Interactive comment on “Evaluation of the IAGOS-Core GHG Package H₂O measurements during the DENCHAR airborne inter-comparison campaign in 2011” by Annette Filges et al.

Author's response to Interactive comment by Anonymous Referee #1 on “Evaluation of the IAGOS-Core GHG Package H₂O measurements during the DENCHAR airborne inter-comparison campaign in 2011” by Annette Filges et al.

Fig. 1. fig03_dew point mirror calibration

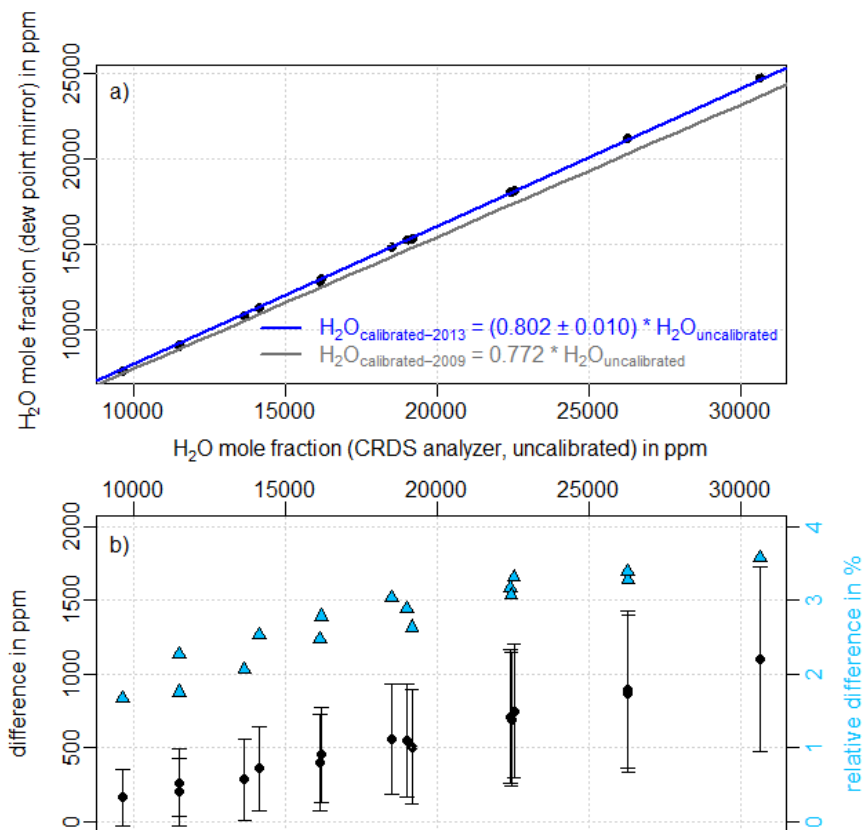
14) Pg 9, L30-32 and Figure 3: Are the reported uncertainties 1-sigma? 2-sigma? This comment applies to the entire paper, wherever uncertainties are given (text and Figures).

16) Pg 10, L12-14, L20: The differences between calibration curves presented in ppm in Figures 3b and 4b and expressed in ppm and % (rel) in the text may cause confusion here. If you express all mixing ratios, differences and residuals in ppm it avoids any confusion. For the Figures 3b and 4b it would add value to include a right axis of relative differences/residuals. Given the near-linearity of the differences/residuals against mixing ratios, I think the relative data (different symbol/color) would be quite constant over the entire range of mixing ratios.

A right axis of relative differences/residuals was added in Figures 3b and 4b.

Added in Caption of Figure 3: "... calibration. The relative differences are plotted on the right axis as light blue triangles."

Fig. 3. fig05_FishCalBench calibration

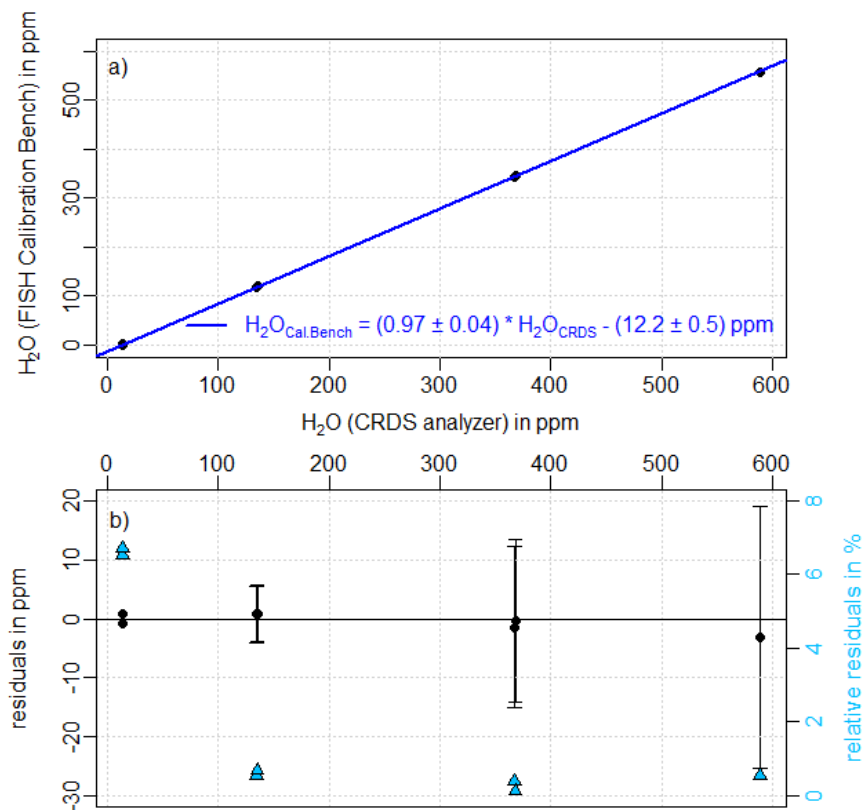
19) Pg 11, L5-13 and Figure 5: The residuals in Figure 5b (presented in ppm) are discussed in the text in relative (%) terms. Adding a right axis for relative residuals to Figure 5b (using different symbol/color) would strengthen the discussion of relative residuals in the text.

A right axis of relative differences/residuals was added in Figures 5b.

Added in Section 3.2.2, page 11 line 8-10: “... residuals ... for water vapors > 100 ppm, which can be seen in plot (b), are small compared to the uncertainty range of the FISH calibration bench of 4 % indicated by the error bars. For the measurement point at 2 ppm water vapor the relative residuals are larger (6.2 %), due to the influence of the 12.2 ppm offset.

Added in Caption of Figure 5: “...of 4 %. The relative residuals are plotted on the right axis as light blue triangles.”

Fig. 4. fig06_dilution calibration

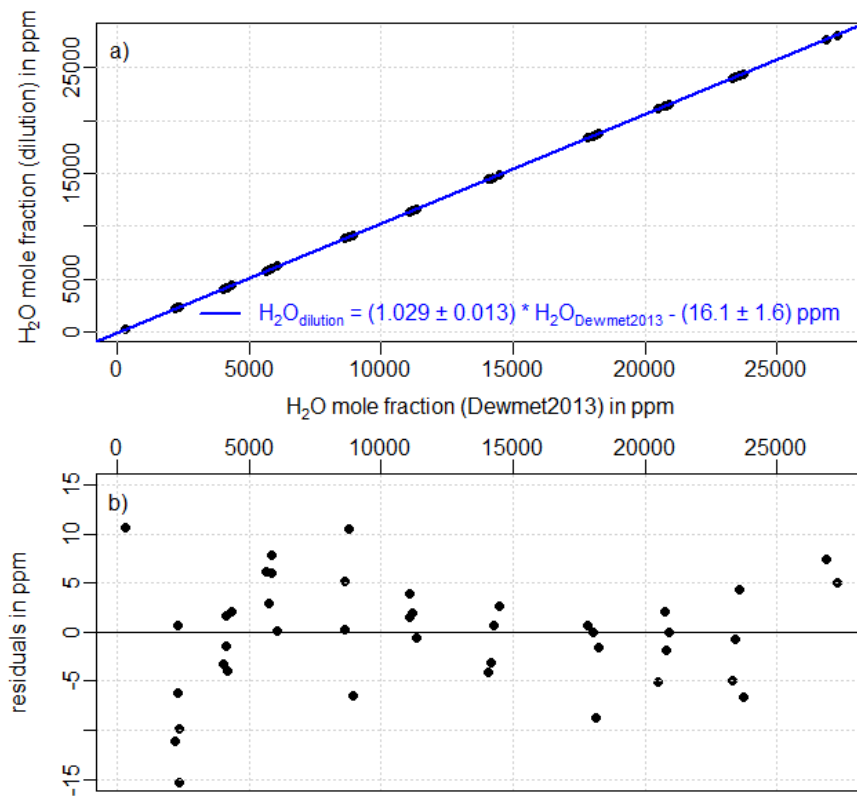
20) Pg 11, L30-31: It is odd that the residuals at 250 ppm are negative (Figure 6b) while at the lowest mixing ratio they are positive. With an offset of 16 ppm one would expect the residuals at both of the lowest mixing ratios to be of the same sign. Any idea why they are negative at 250 ppm and positive at the lowest mixing ratio?

21) Pg 12, L1: If "the lowest measurement was made at around 300 ppm", why are there data points below 300 ppm in Figure 6?

The residuals are negative at 2500 ppm, not 250 ppm, and positive at 300 ppm. Unfortunately there is only one data point at 300 ppm. With more measurements at this water vapor level we would expect the scatter/pattern of the residuals to be similar to

the ones at other water vapor levels. Therefore, as described in Section 3.2.3, the uncertainty range of 1.6 ppm of the offset is likely unrealistic and follow on experiments should contain more measurements at low water vapor levels (<300 ppm).

There are no data points below 300 ppm. 1 % water vapor mole fraction corresponds to 10000 ppm, not 1000 ppm. For clarification all water vapor values were changed to ppm in the text and figures.

Fig. 5. fig07_measurement precision

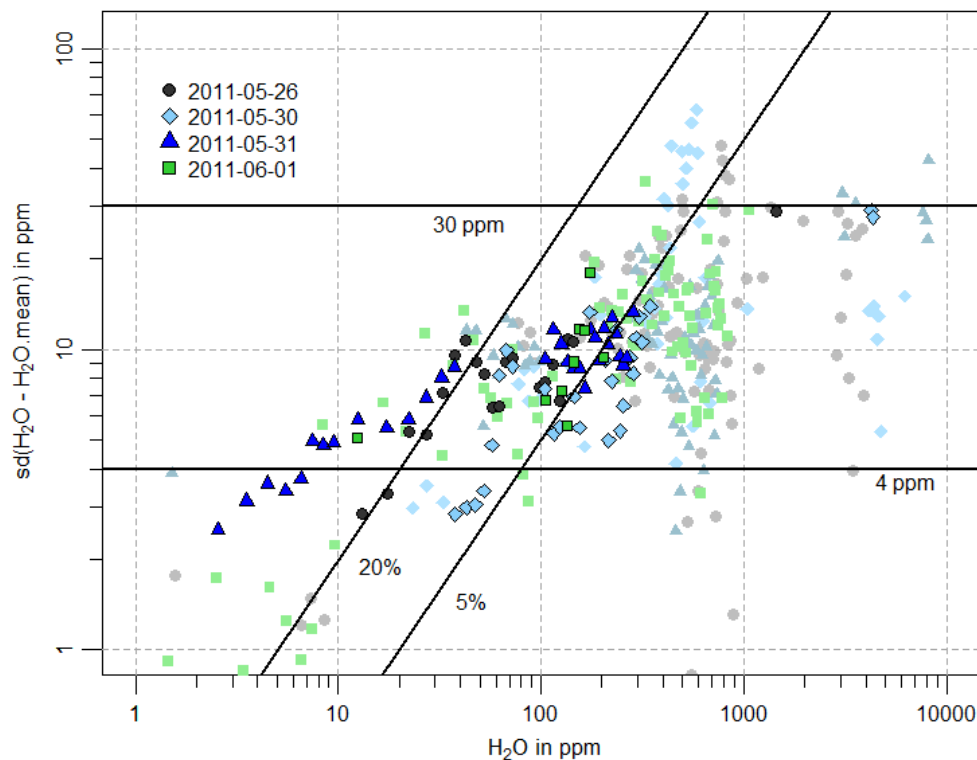
General Comments 1) I don't agree with the measurement "repeatability" values determined in this paper for WV mixing ratios <100 ppm. On page 14 it is stated that an "upper limit for the measurement repeatability" .. is : : : "4 ppm or 5%, whichever is

greater for $WV < 100$ ppm". If that is the case, why are there so many data points for $WV < 100$ ppm in Figure 7 that have standard deviations > 5 ppm (5%)? The upper limit estimate for $WV > 100$ ppm is much more in line with the Figure 7 data.

33) Pg 14, L26-27: "upper limit" ... "4 ppm or 5%, whichever is greater for WV < 100 ppm". In Figure 7, why are there so many data points for WV < 80 ppm that have standard deviations > 4 ppm (5%)? The upper limit estimate for WV > 100 ppm is much more in line with the Figure 7 data: most of the data points for WV > 100 ppm lie below the 30 ppm standard deviation line and to the right of the 5% diagonal. This cannot be said about the WV < 100 ppm data, many of which lie above the 4 ppm standard deviation line and to the left of the 5% diagonal. Please explain the connection between this Figure and the numbers you have extracted from it that appear to underestimate the precision values for measurements at WV < 100 ppm.

Measurement repeatability values were revised. The new estimates are 4 ppm for $H_2O < 10$ ppm, 20 % or 10 ppm (whichever is smaller) for $10 \text{ ppm} < H_2O < 100$ ppm, and 5 % or 30 ppm (whichever is smaller) for $H_2O > 100$ ppm

Added in Figure 7: line indicating a standard deviation of 20 %

Added in caption of Figure 7, line 6: "... of 4 and 30 ppm, and 5 and 20 % respectively."

Fig. 6. fig08_response time wet-dry

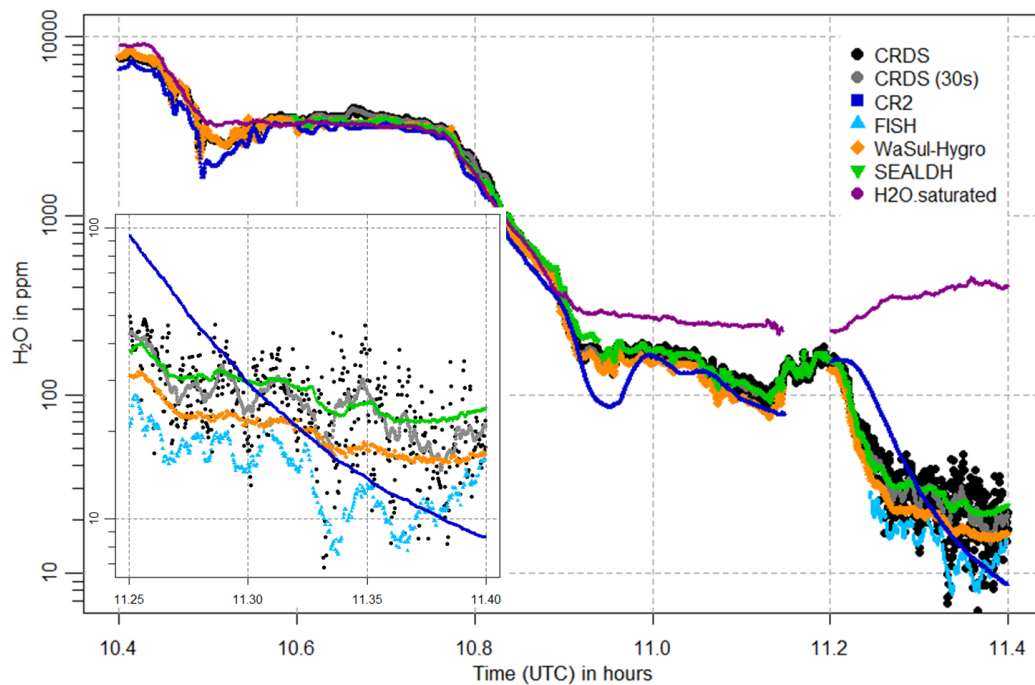
34) Pg 15, L9-16: No need to describe the different symbols since that is done in both the Figure 8 caption and legend. What is more important here is a description of what the Figure shows about response time of the CRDS. I think that showing only a short period of Figure 9 would better support this discussion of response times <10 seconds. Specifically, the flight segment from 12.35 to 12.55 UTC on 1 June 2011 when water vapor increases and falls an order of magnitude in about 3 minutes.

Enlarged sections for selected shorter time periods are added in Figure 8 and 9.

Added in Caption of Figure 8: "... flight on 31 May 2011. An enlarged section for the time period from 11:15 to 11:24 is shown in the lower left part of the plot."

Added in Section 4.1.2, page 15 line 19: "... to wet. For water vapors <100 ppm the response time is comparable to the FISH instrument, as shown in the enlarged section of Fig. 8. During the increase of water vapor from 200 to 1200 ppm in about one minute, shown in the enlarged section in Figure 9, no significant delay can be detected. Thus, ..."

Fig. 8. fig11_absolute differences_all flights

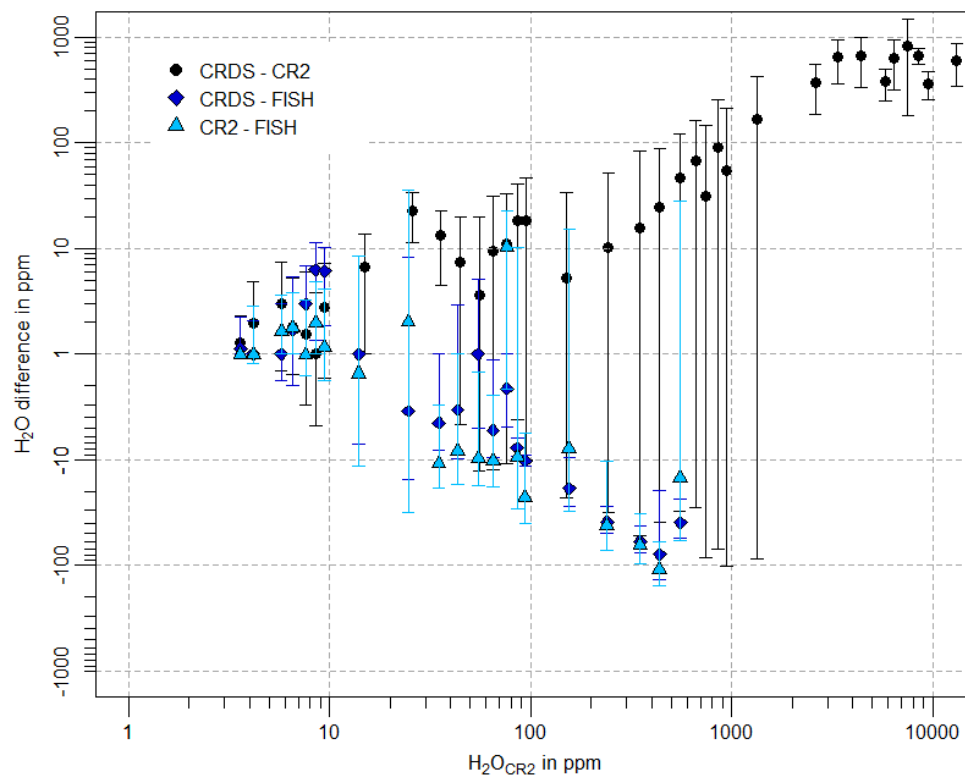
36) Pg 15, L27-31 and Pg 16 L1-6: Please remove Figure 11 symbol descriptions and the explanation of data binning since all this information appears in the Figure caption.

37) Pg 16, L1-2 and Figure 11 caption: "Absolute" differences steers my thinking towards absolute values, which are definitely not what Figure 10 shows. "Absolute" is unnecessary in both instances because the differences are clearly in units of ppm, i.e., not relative differences.

38) Pg 16, L4-6 and Figure 11: If the differences are binned by CR-2 water vapor in 1 ppm bins for CR-2 < 10 ppm, why are there multiple blue diamonds and multiple blue triangles in the lowest CR-2 mixing ratio bin (and some other bins)? Aren't the averages computed from all segments of all flights? If not, why are the average differences in each bin determined for subsets of the 4 flights?

39) Figure 11: The log-scale Y-axis is problematic for average differences < 1 ppm and for the error bars that appear asymmetric around the mean. Why don't you instead plot average relative (%) differences using a linear-scale Y axis? Average differences < 1 ppm will then be displayed correctly and the error bars will be symmetric around the mean values. I think the relative values will be much more like flat lines with CRDS-CR2 values above zero and the other instrument pairs below zero.

Descriptions and explanations were removed. See answer to General Comment 5.

Changed in Figure 11, caption: "Differences ..."

Figure 11 was corrected. Now there is only one data point for each bin.

We plotted the relative differences using a linear axis, too. The problem with this display

is that for water vapors <100 ppm, and especially <10 ppm, the relative differences are very large (up to 50-100 %). For the interpretation of the results at <100 ppm a plot with differences in ppm is much clearer and easier to understand. So, both representations have their pros and cons. In the end we decided that the plot with the log-scales is a bit better suited for our purposes.
